**TECHNICAL REVIEW PLAT REQUIREMENTS  
REGULAR PLANNING COMMISSION MEETING  
JANUARY 6, 2021**

PROJECT: 20PL1120

100 SOUTH PADRE UNIT 6, BLOCK 5, LOTS 17 AND 18 (FINAL – 4.69 ACRES)

**TECHNICAL REVIEW COMMITTEE (TRC) PLAT REVIEW COMMENTS**

**Plat of  
100 South Padre, Unit 6  
Block 5, Lots 17 and 18**

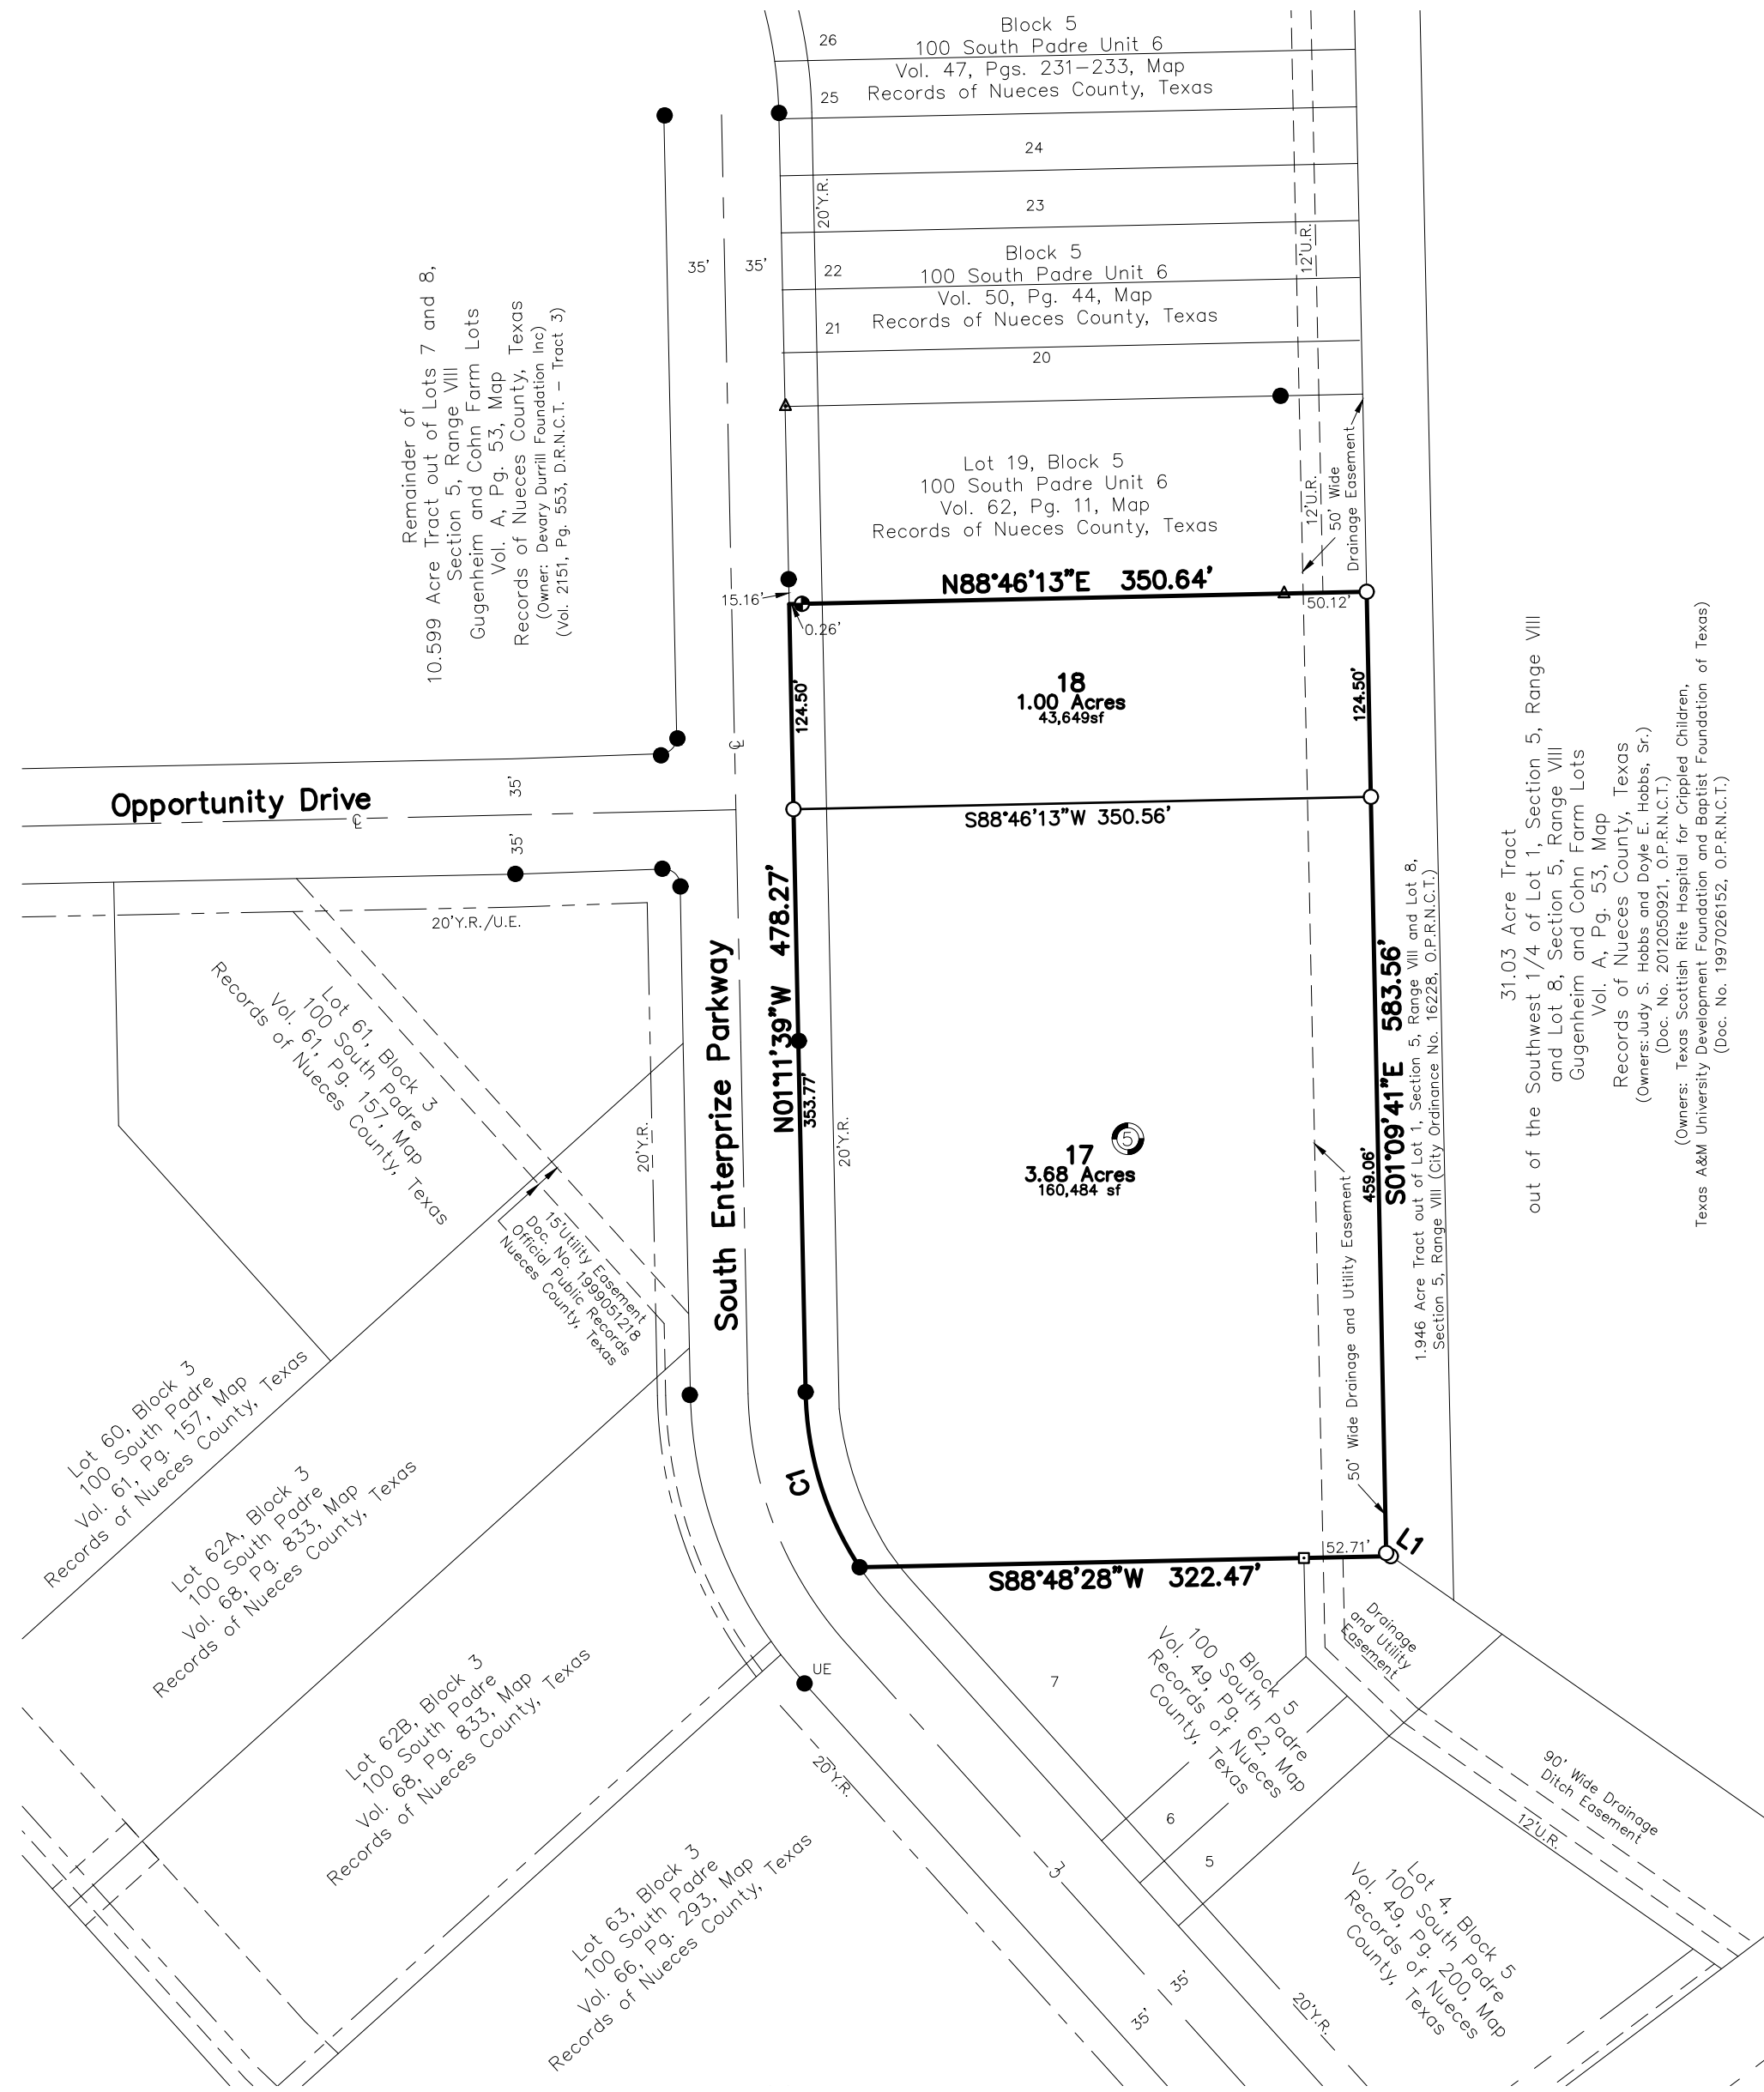
DEVELOPMENT SERVICES ENGINEERING						
No.	Sheet	Comment	Applicant Response	Staff Resolution	Applicant Response	Staff Resolution
1		Clarify the ownership and the use for the existing pickup / drop off lane; dedicate to the City if it is used by any public system.	Currently Owned by the Devary Durrill Foundation. RTA currently does not utilize the stop and other properties recently platted have not dedicated park presumably because city does not want it.	Addressed		
4	Plat	Add the following note "all driveways shall conform to access management standards outlined in Article 7 of the UDC".	Note has been added	Addressed

TRAFFIC ENGINEERING						
No.	Sheet	Comment	Applicant Response	Staff Resolution	Applicant Response	Staff Resolution
1	Plat	Proposed driveway access to a public City Street shall conform to access management standards outlined in Article 7 of the UDC	Understood	Addressed

5. The yard requirement, as depicted is a requirement of the Unified Development Code and is subject to change as the zoning may change.
6. All driveways shall conform to access management standards outlined in Article 7 of the UDC.
